West Coast Shipbuilders Ltd.

9000 TON CARGO VESSEL
INSULATION OF REFRIGERATED SPACES

HULL No. 163-4

DWG. No. 163-53

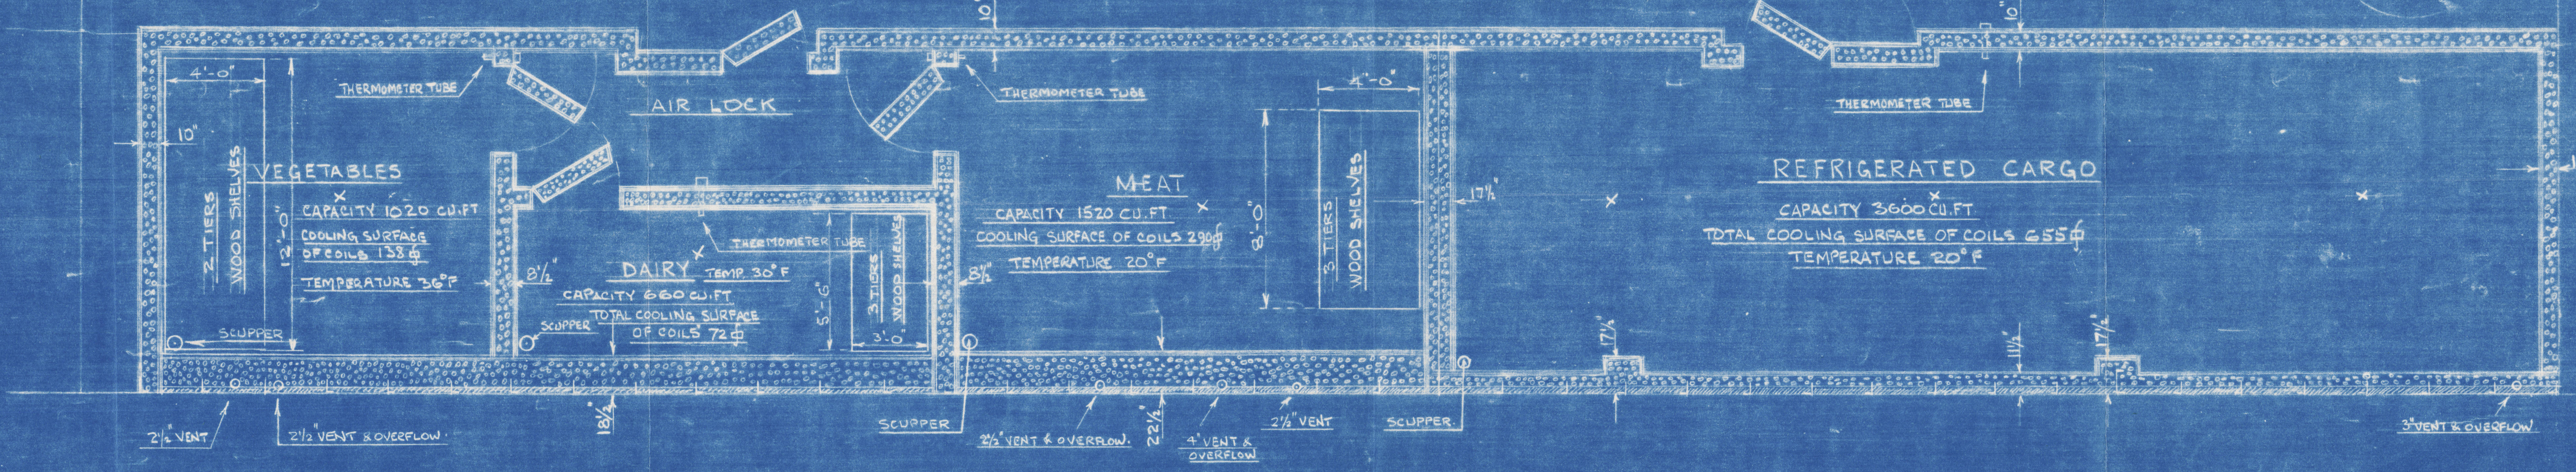
NOV 5TH 1946. THERMOMETER TUBES INCREASED TO 2" DIA. INSIDE OF INSULATION

NOV 1ST INSULATION INCREASED TO 1 1/2" AT SHELL PMS 67-28. CAPACITIES, COOLING SURFACES & TEMPERATURES ADDED.

SEPT 14TH 1946. POSITION OF DOOR IN DAIRY CHANGED. INSULATION ON EXTERIOR SIDES, ENDS & MECHS ADDED.

SEPT 30 1946. WOOD SHELVES ADDED TO DAIRY, VEGETABLE ROOM & MEAT ROOM.
